Development Permit Panel

2. Development Permit 08-418522

3. Development Permit 11-585139
(File Ref. No.: DP 11-585139) (REDMS No. 3408808)

Report to Development Permit Panel Planning and Development Department

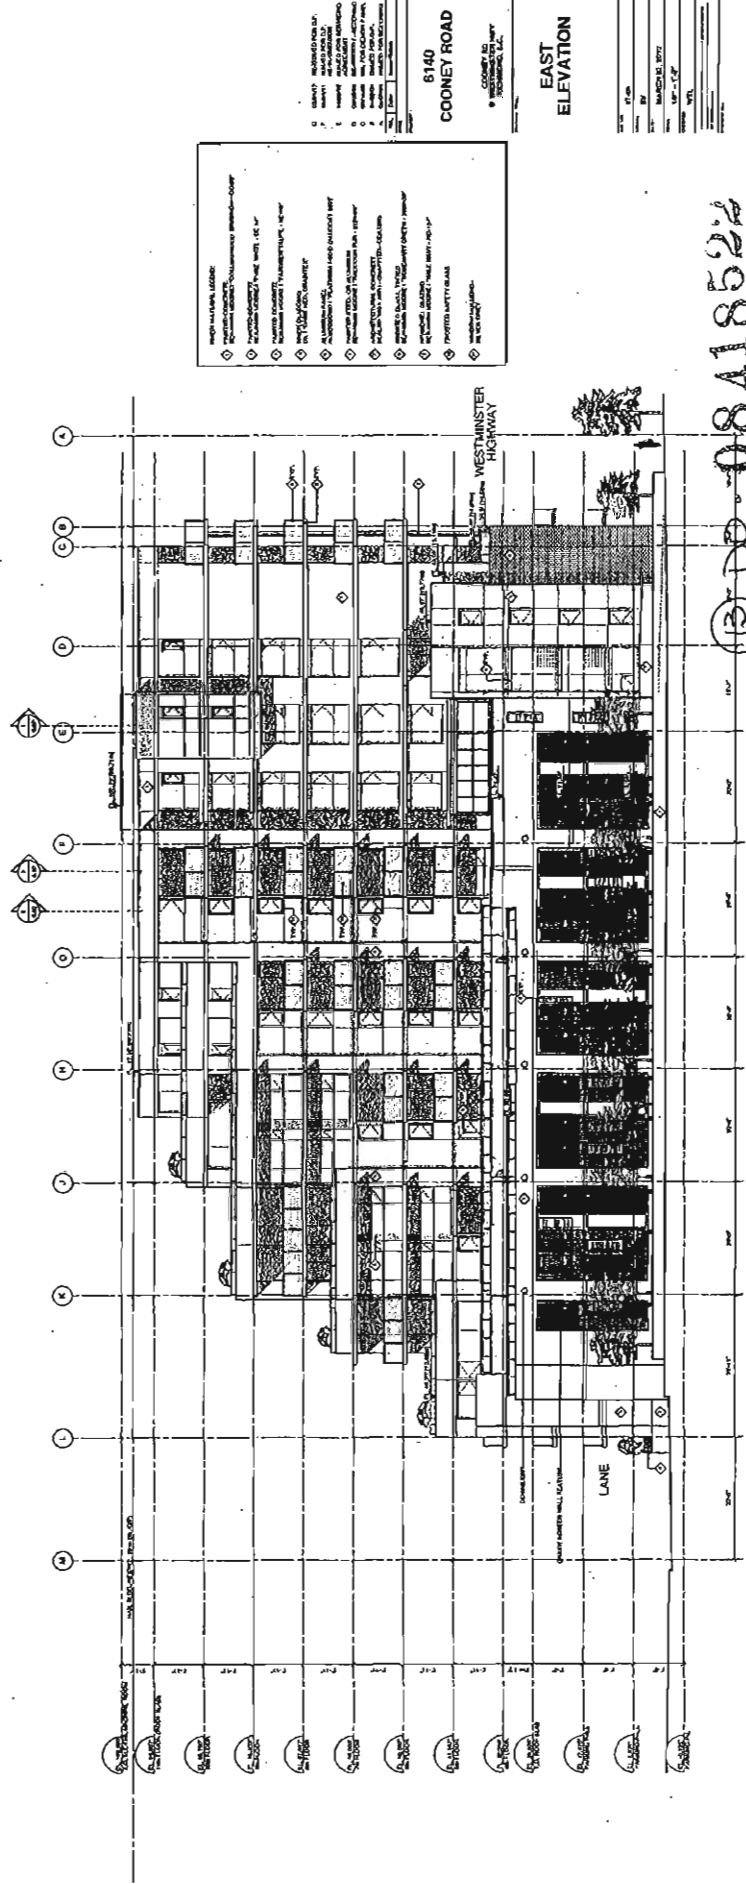
- interface of parkade component with residential building at the east side;
We have lowered the east parkade parapet height by approx. 0.60 m (2 ft) (EL.30.00). Some down lights were added to accentuate the concrete pilasters. The east façade also includes a semi recessed green screen wall feature.

- appreciate the playfulness of the openings on the east parkade elevation; consider introduction of more colour;
The east wall of the parkade has been modified with concrete pilasters, down lights for accentuation and will receive green screen wall panels, where climbers can grow up. The metal grilles behind the green screen will be painted and will reduce glare resulting from car headlights.

We have lowered the east façade parapet height by approx. 0.60 m (2 ft) (EL.30.00). Some down lights were added to accentuate the concrete pilasters. The east façade also includes a semi recessed green screen wall feature.

1
L4
WATER FEATURE BY THE ENTRANCE
SCALE 1/2" = 1'-0"

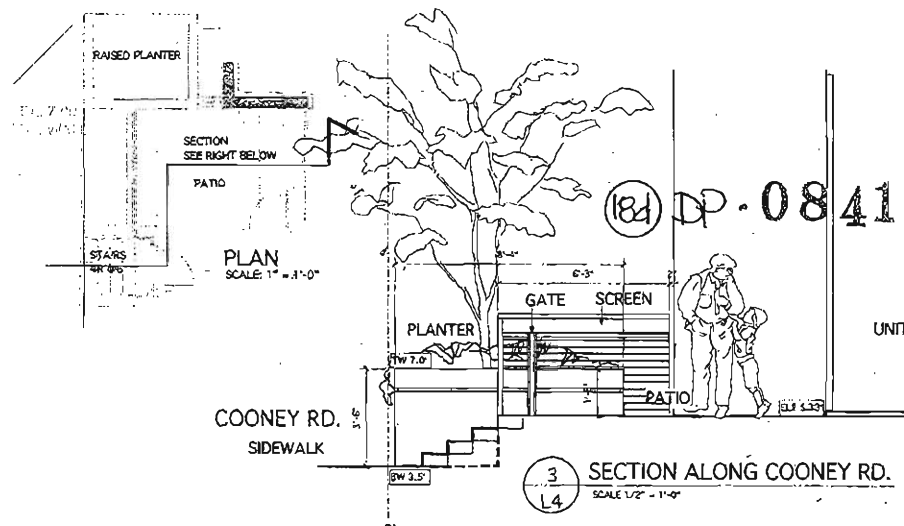
Masa Ito, Landscape Architect of Ito and Associates, with the aid of a model and artist's renderings pointed out that on the ground level in the corner of Westminster Highway and Cooney Road, a sculptural waterfall wall is proposed. It is an eight-foot, free-standing wall with metal cladding and opaque glass proposed to be illuminated at night. He stated that the community garden and an arbour adjacent to the lane are separated by a low (one meter high) picket fence. He also described the landscape plan on the fourth level which features a garden, amenity area, extended amenity room, play area, arbour and lawn. The level 5 rooftop is not indicated to be landscaped as only one unit has access to the area.

SITE PLAN
SCALE 1" = 40'-0"

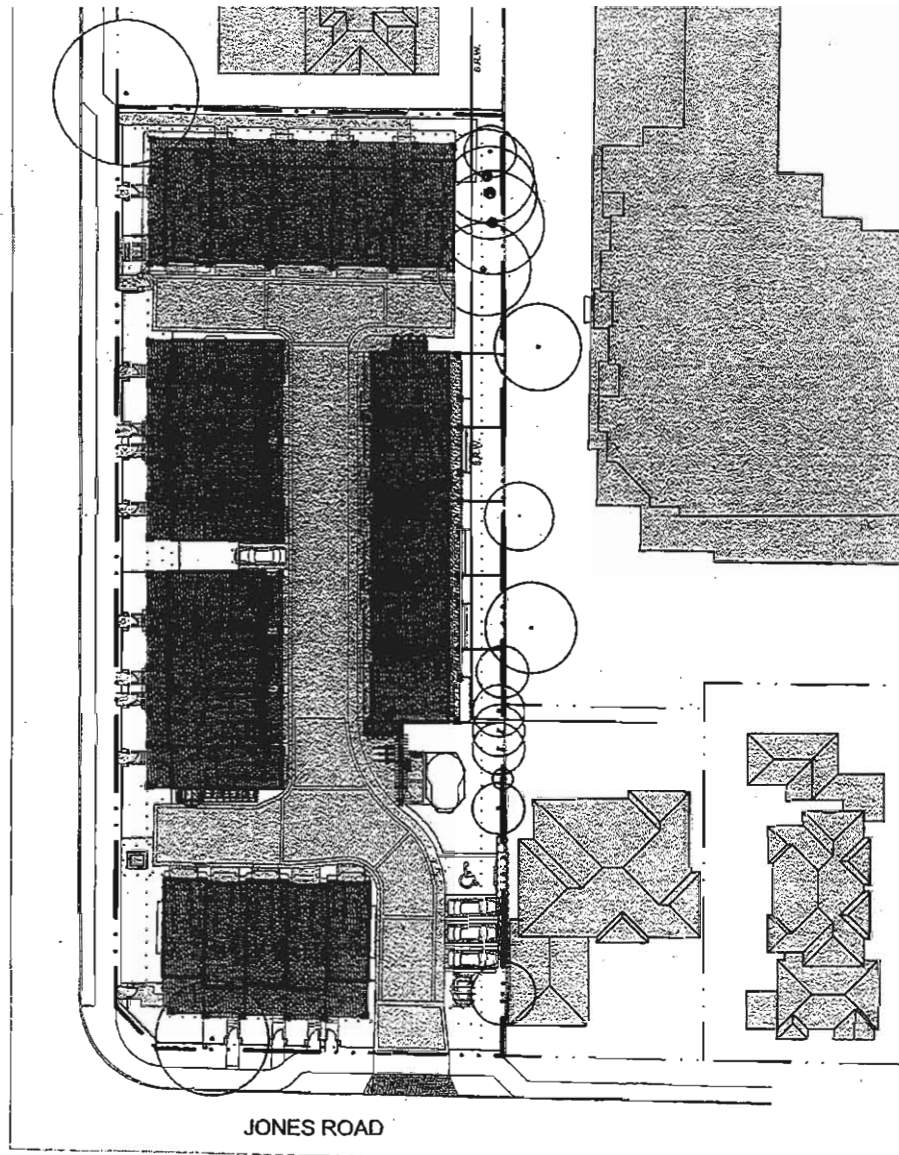
2. Landscape plan provided by the applicant shows the sidewalk up against the curb along St. Alban's Road; consider introducing a boulevard between the curb and the sidewalk where trees could be planted; will make the development look warmer and more friendly;
